**RE: New Mexico International Playground Improvements
7215 Montgomery Blvd. NE
Grading and Drainage Plan
Engineer's Stamp Date: 09/04/2024
Hydrology File: F19D003B**

Based upon the information provided in your submittal received 09/10/2024, the Grading & Drainage Plan is approved for Building Permit, and Grading Permit. Please attach a copy of this approved plan in the construction sets for Building Permit processing along with a copy of this letter.

GRADING PLAN

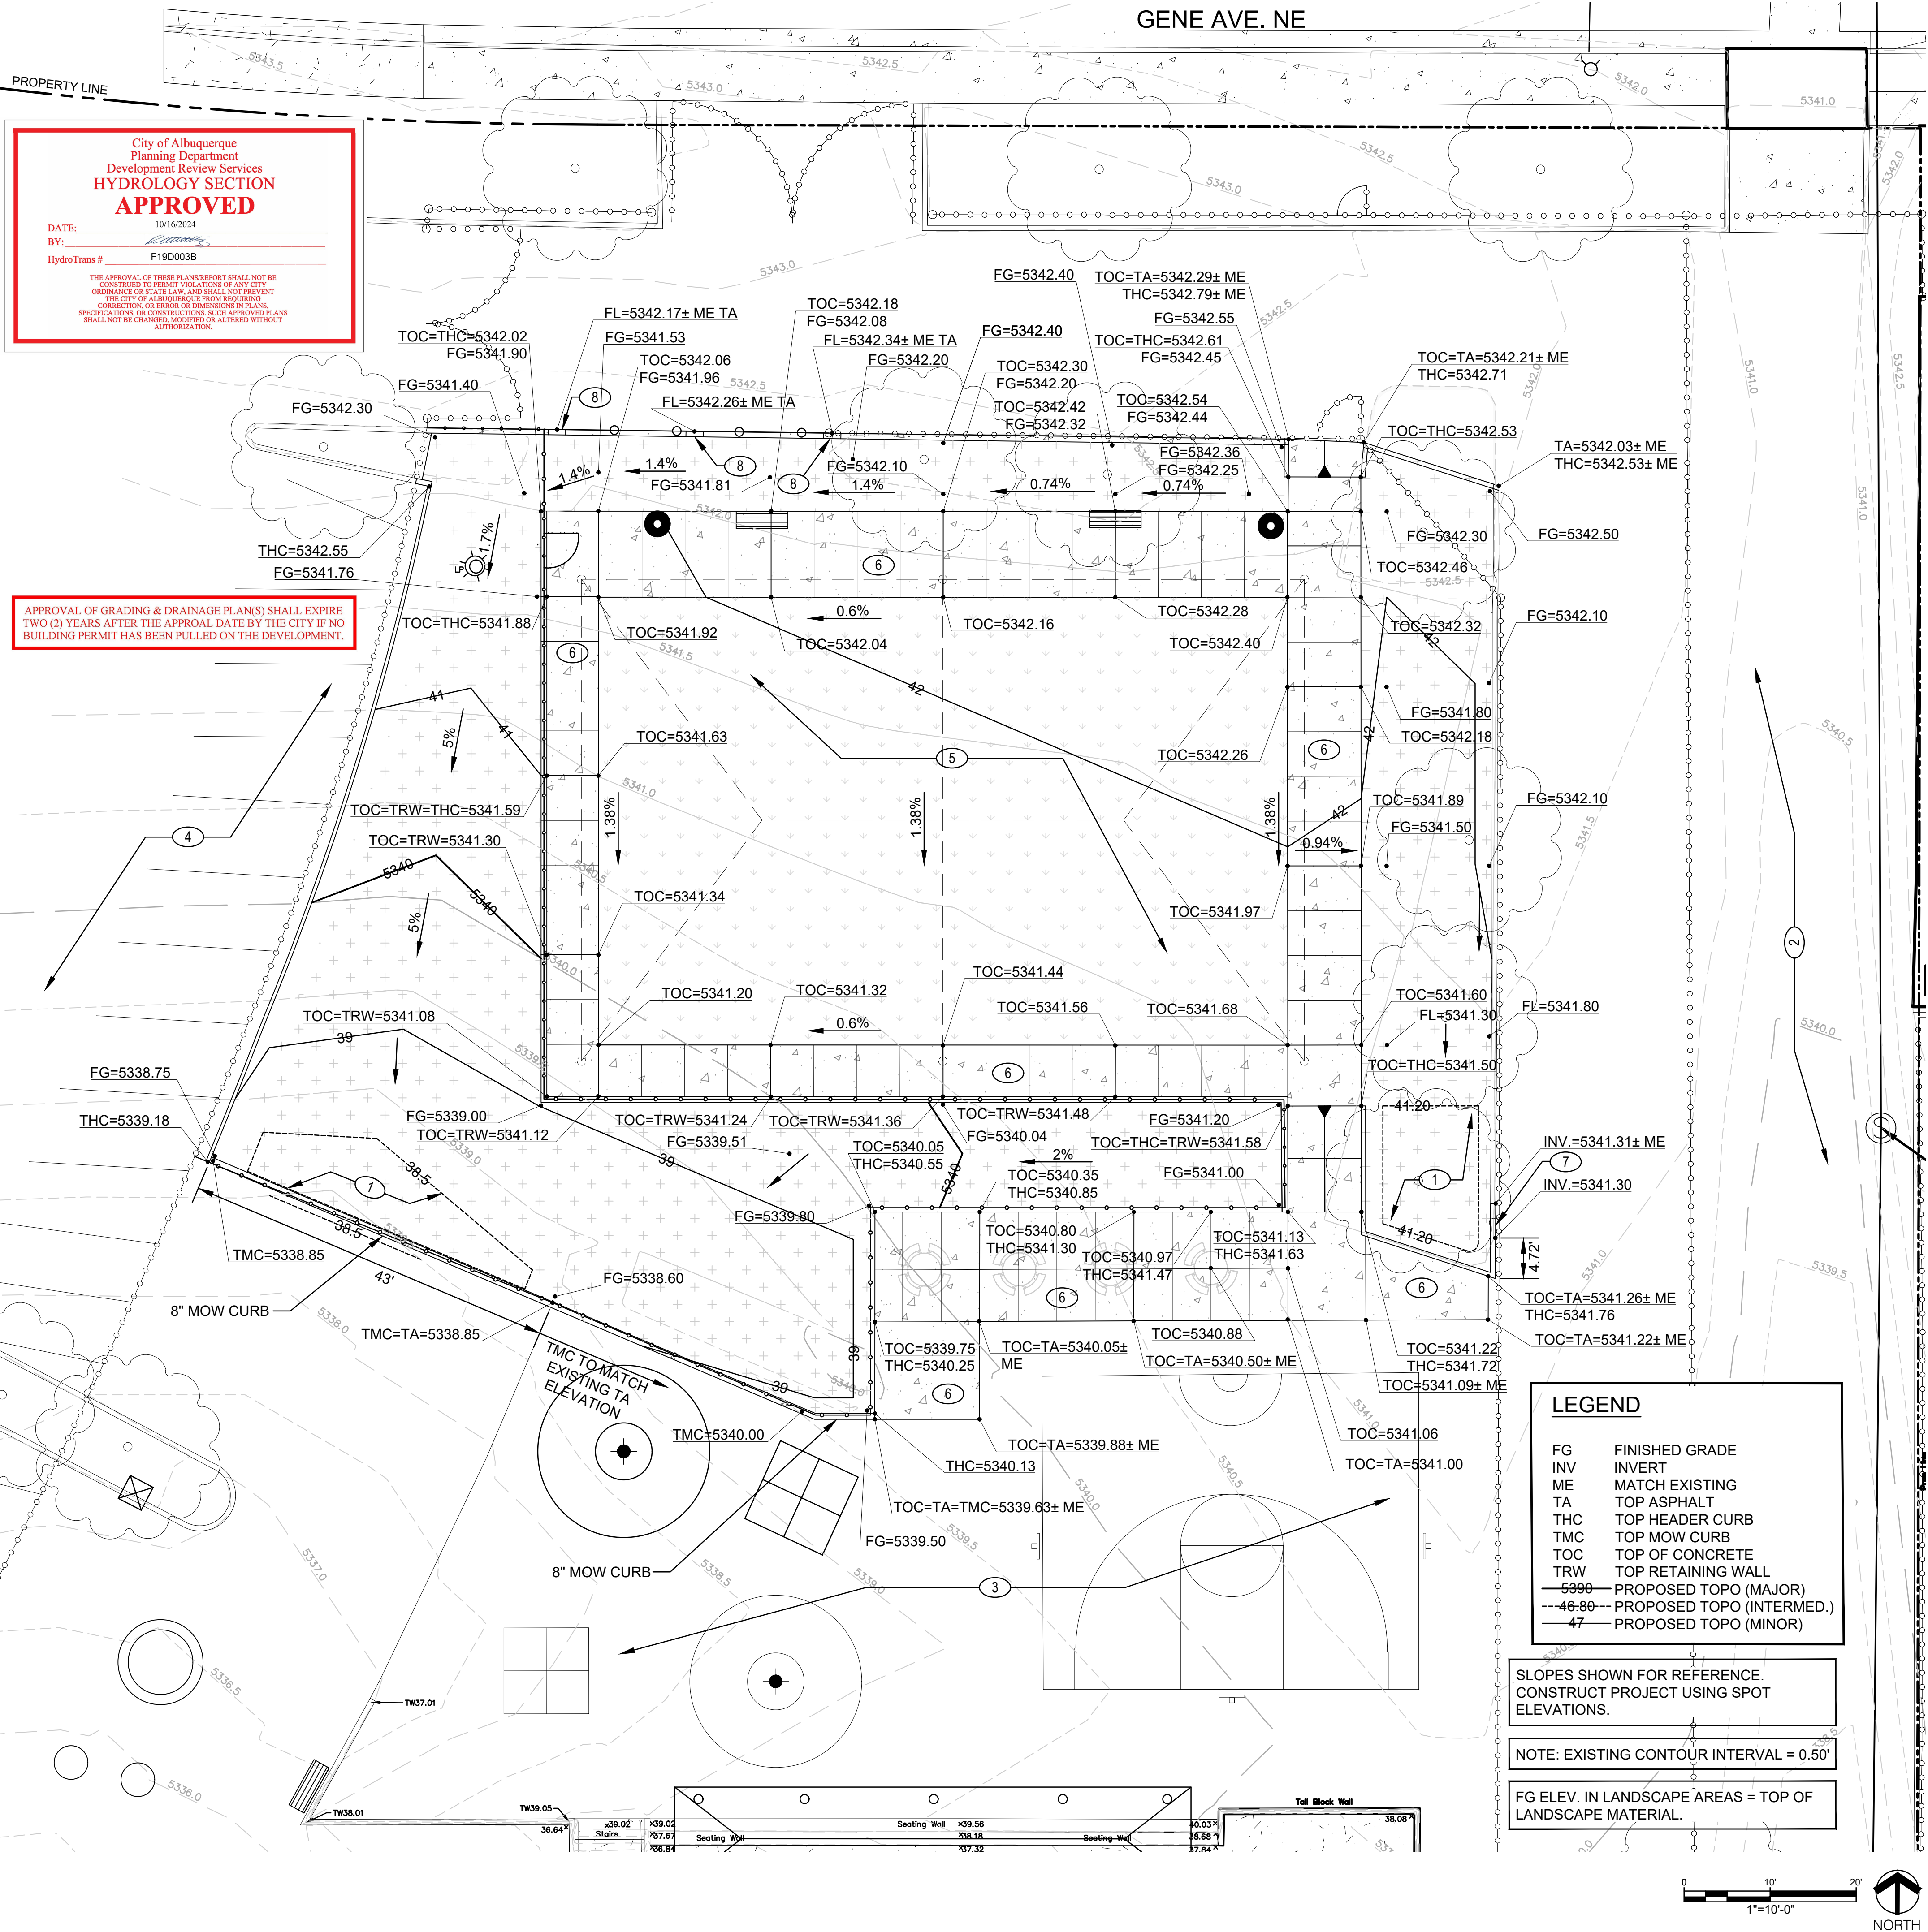
1. Engineer's Certification, per the DPM Part 6-14 (F): *Engineer's Certification Checklist For Non-Subdivision* is required.
